ADDENDUM NO. 2

Whiteland Community High School Phase 2A
300 E. Main Street
Whiteland, IN 46184

PROJECT: Whiteland Community High School Phase 2a

DATE OF ADDENDUM: May 2, 2024

GRADING PLAN

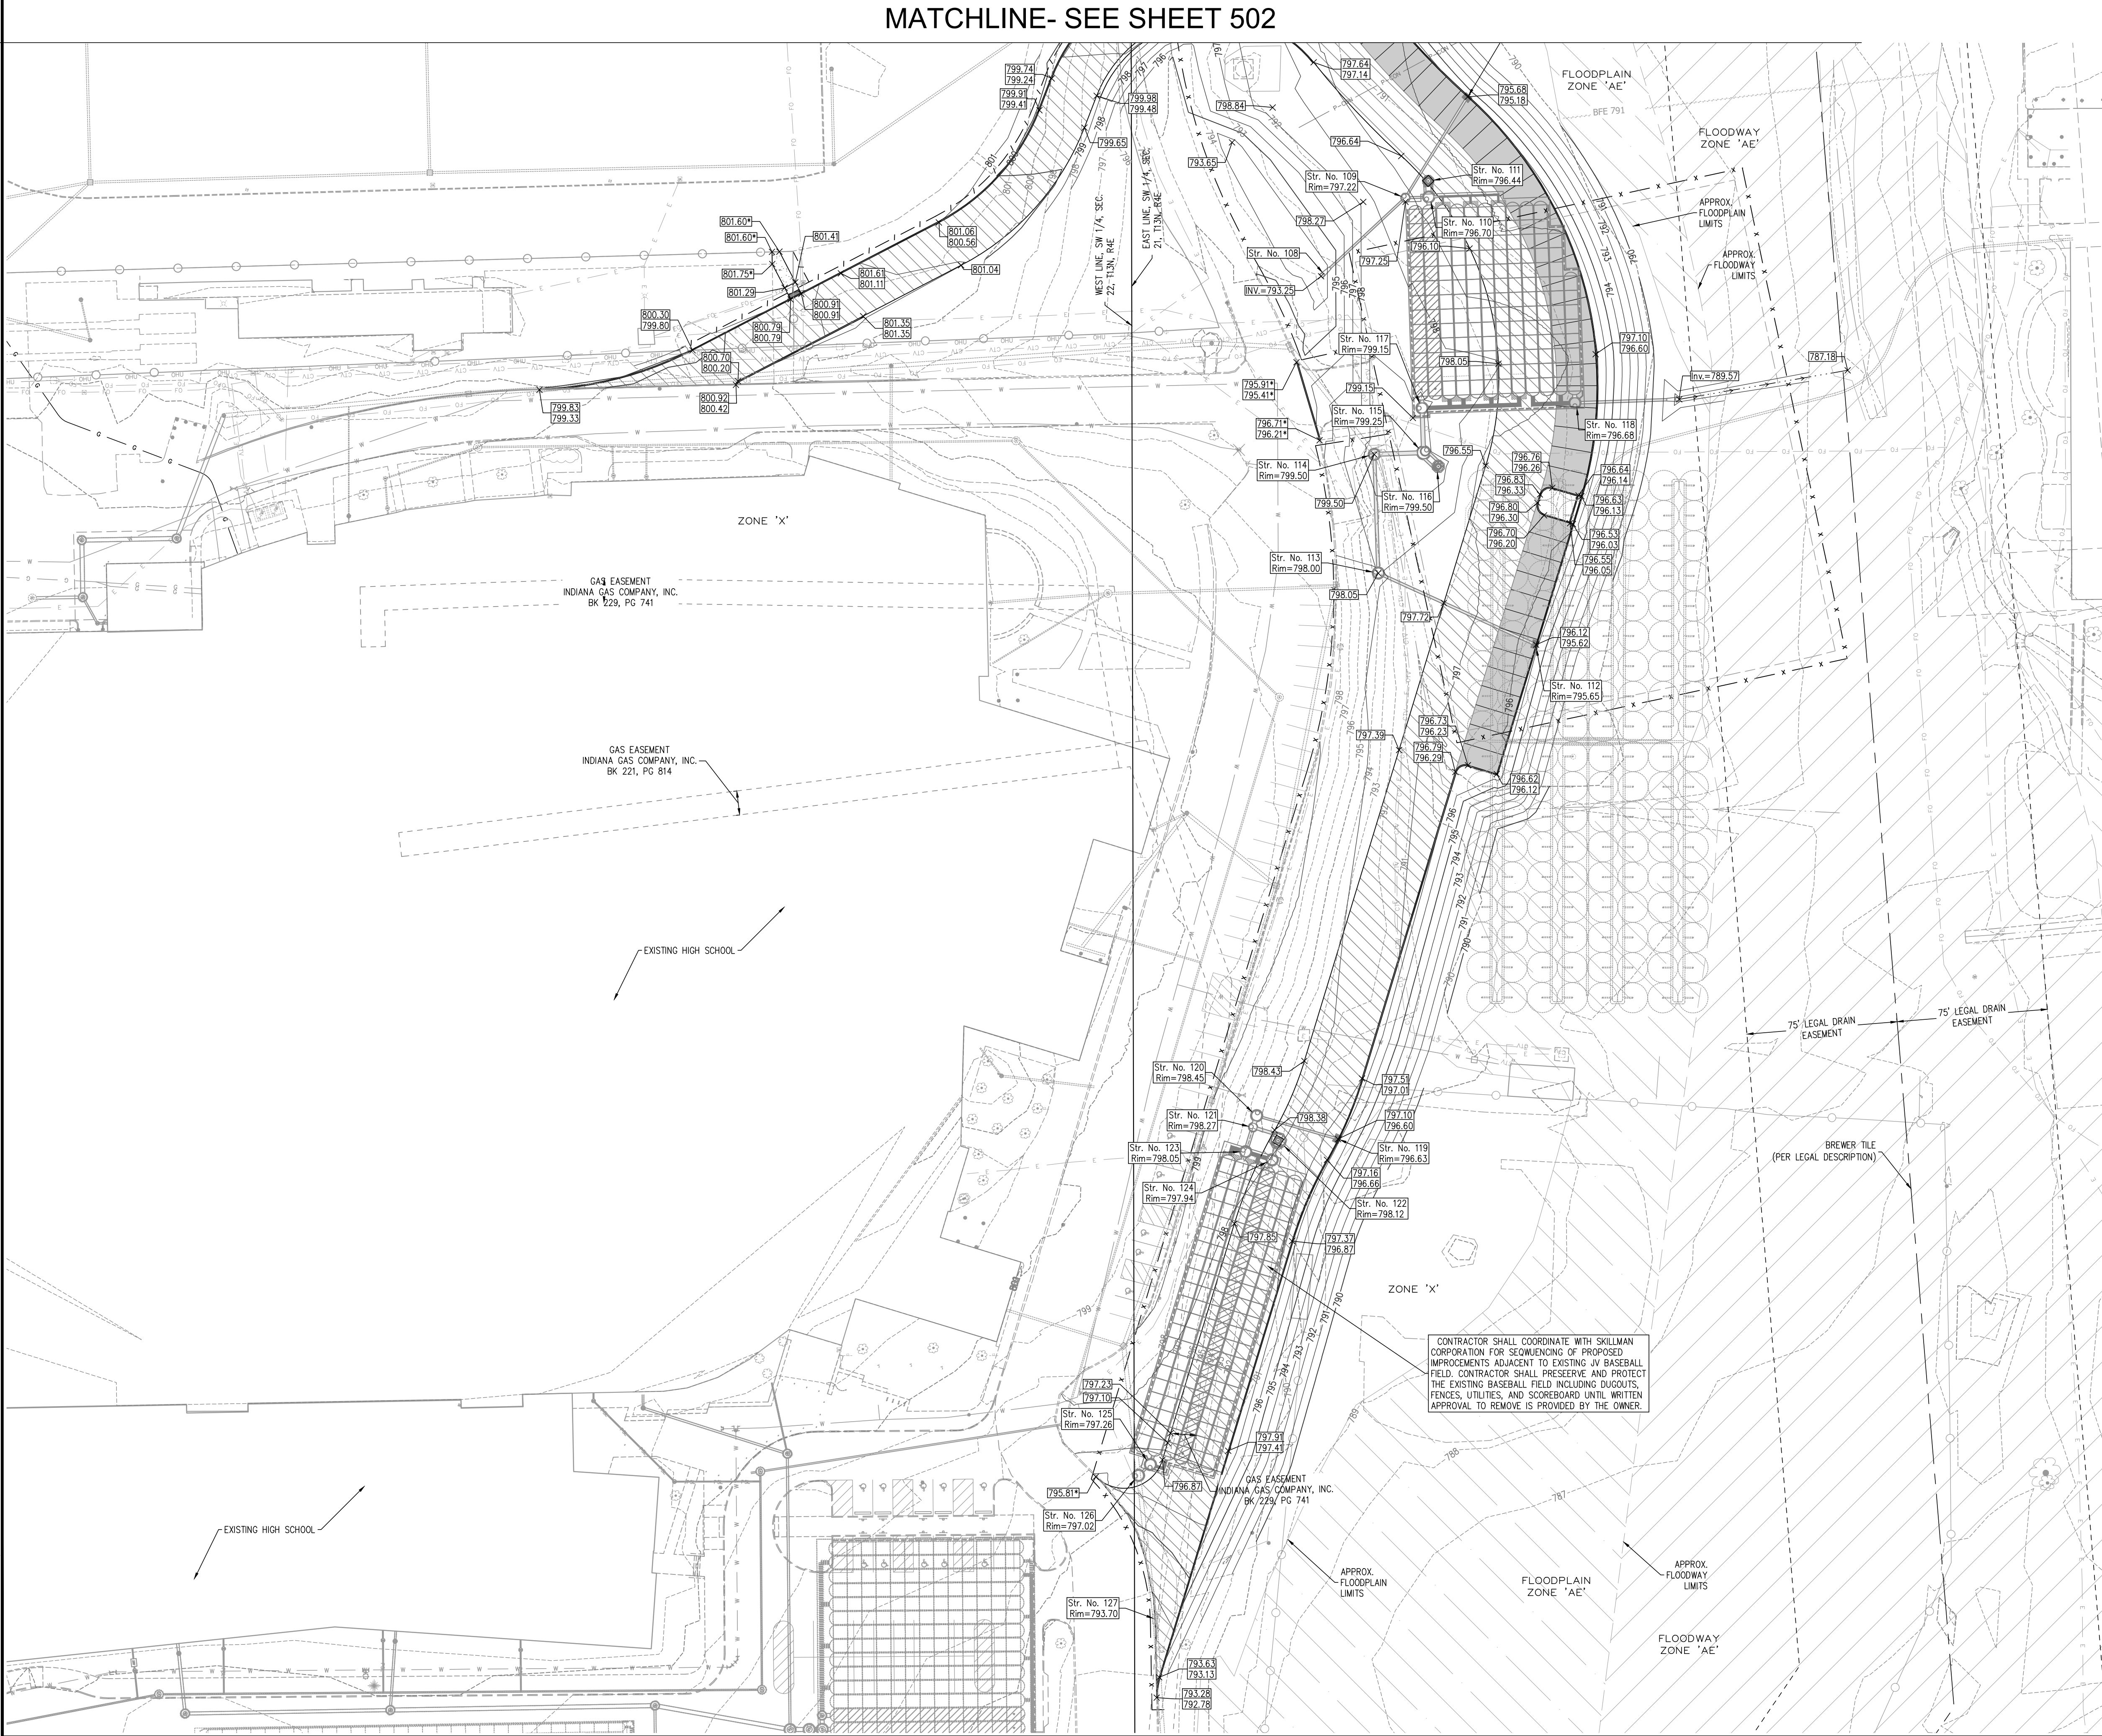
8 Grading Plan (sheet 502):

- o Revised grading per revised long jump location.

503

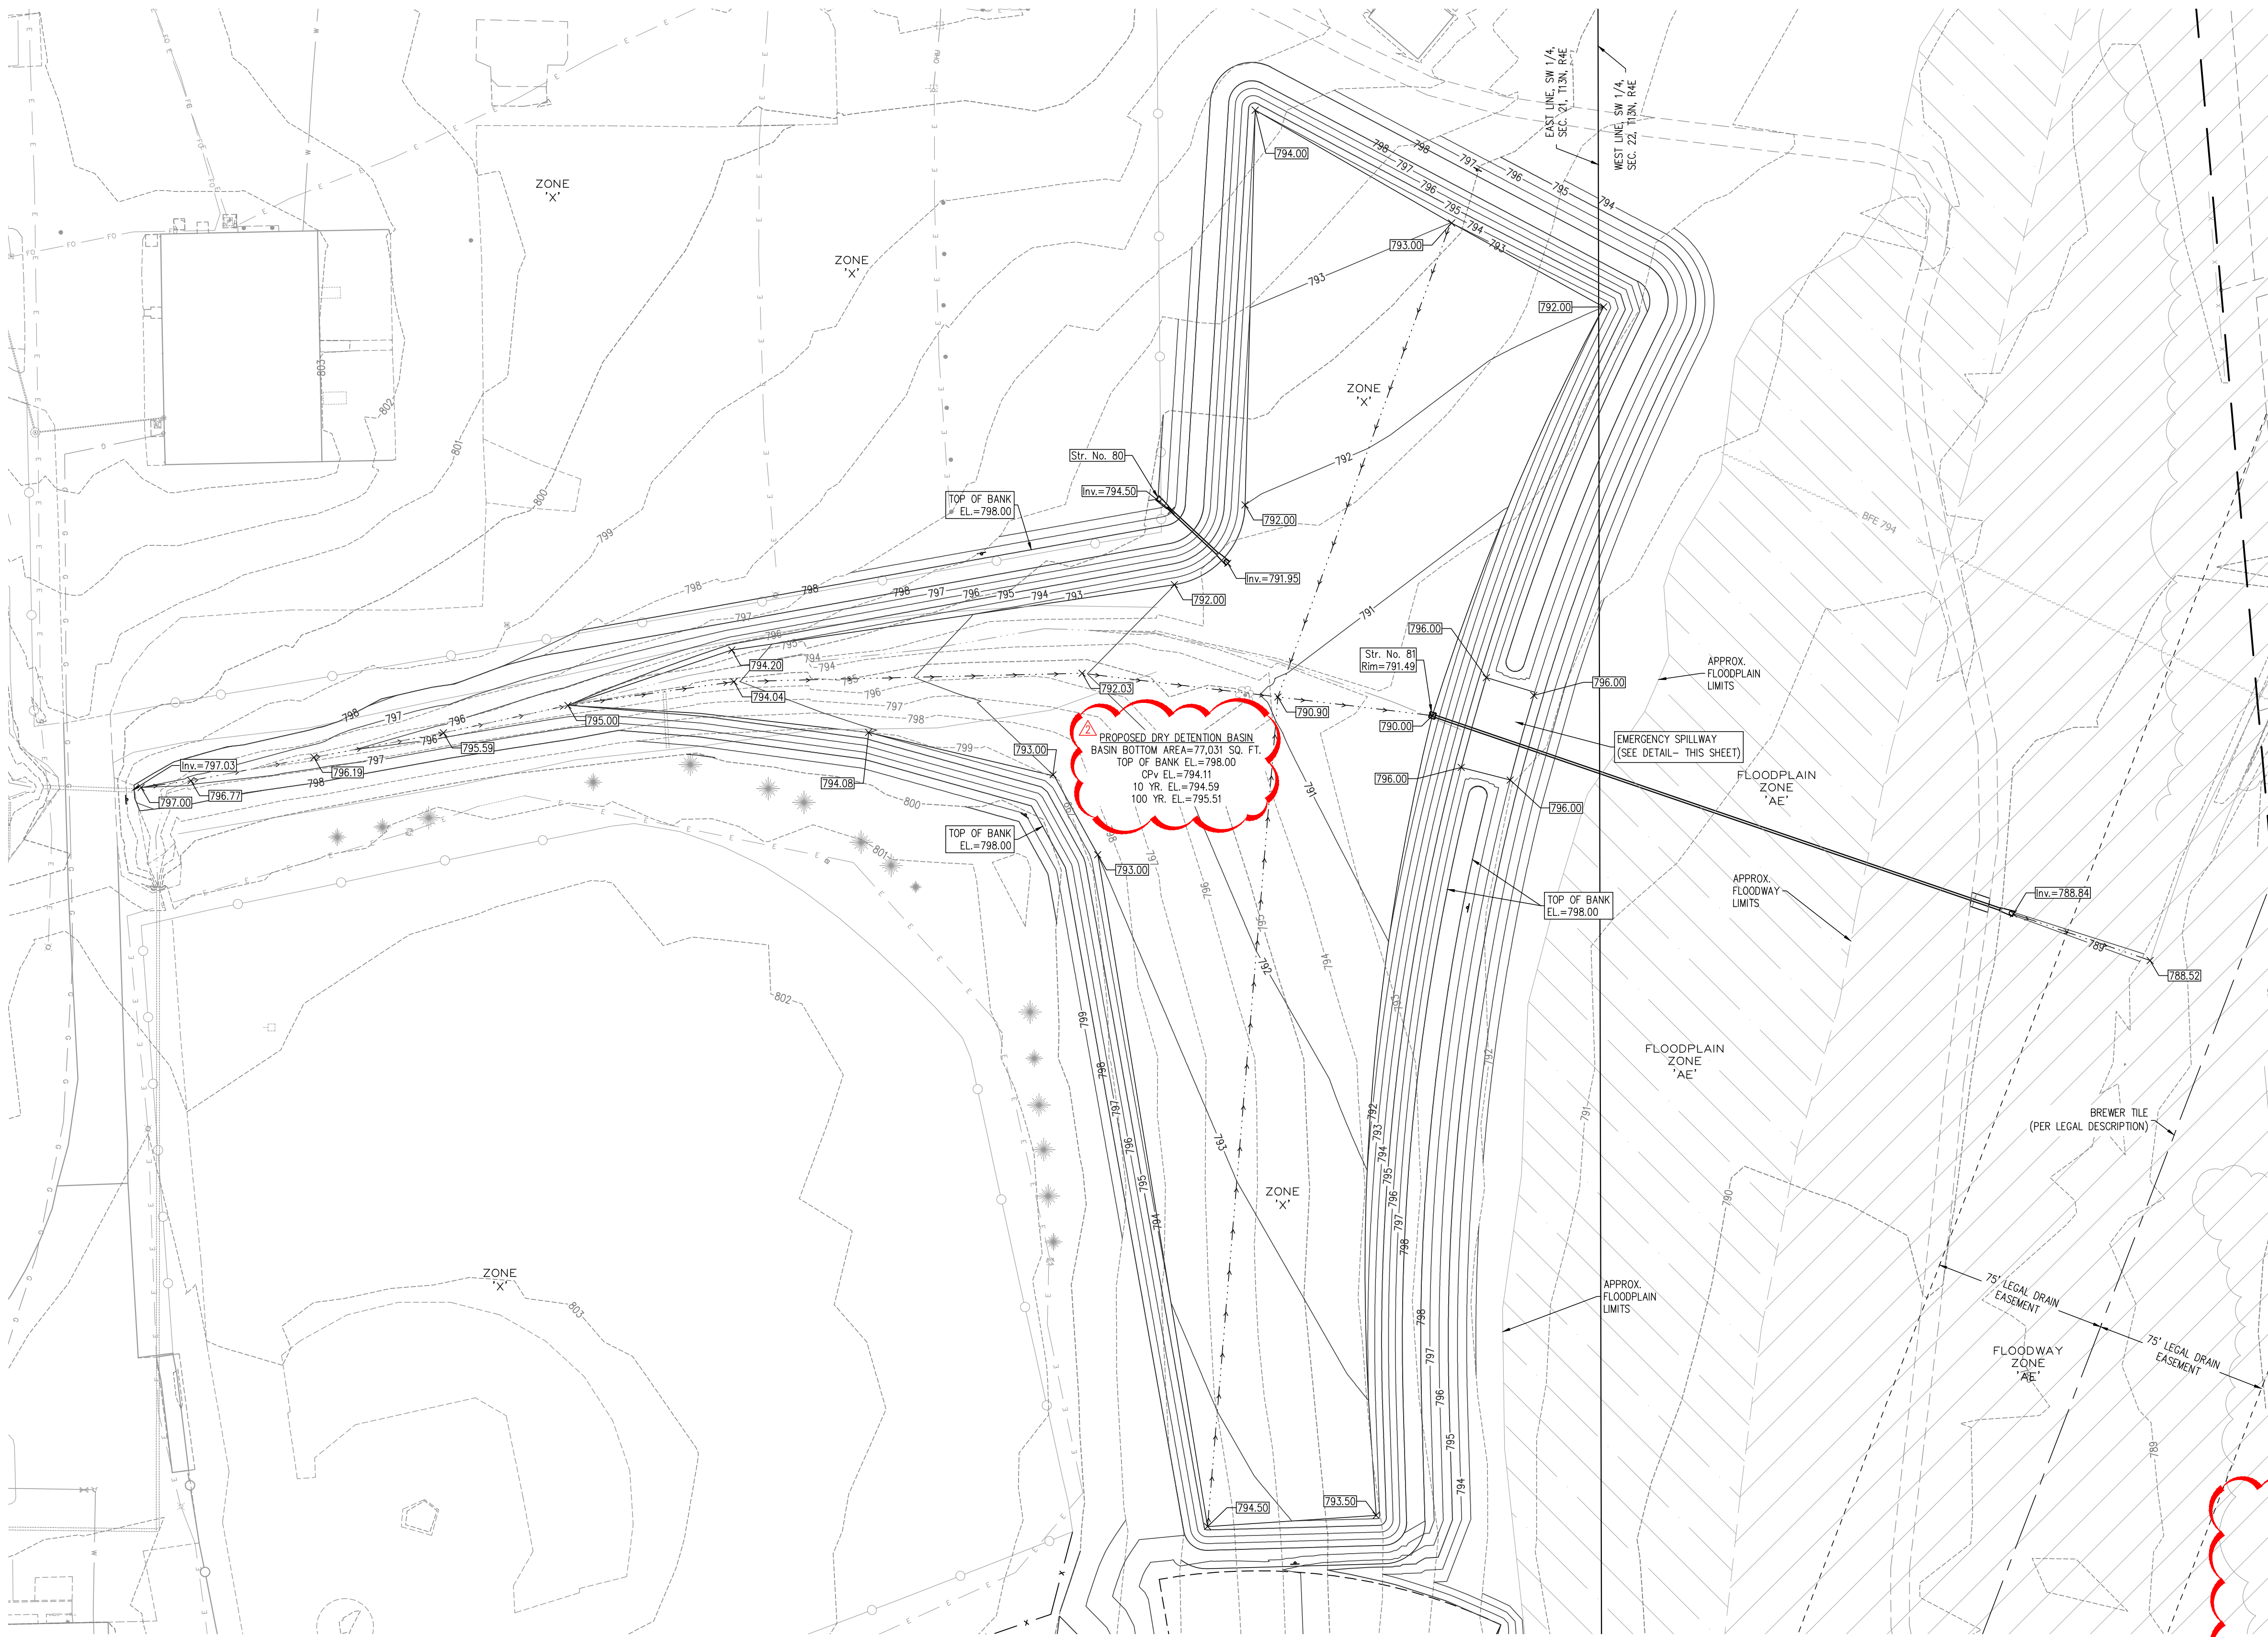
9 Curb Ramp Grading Details (sheet 503):
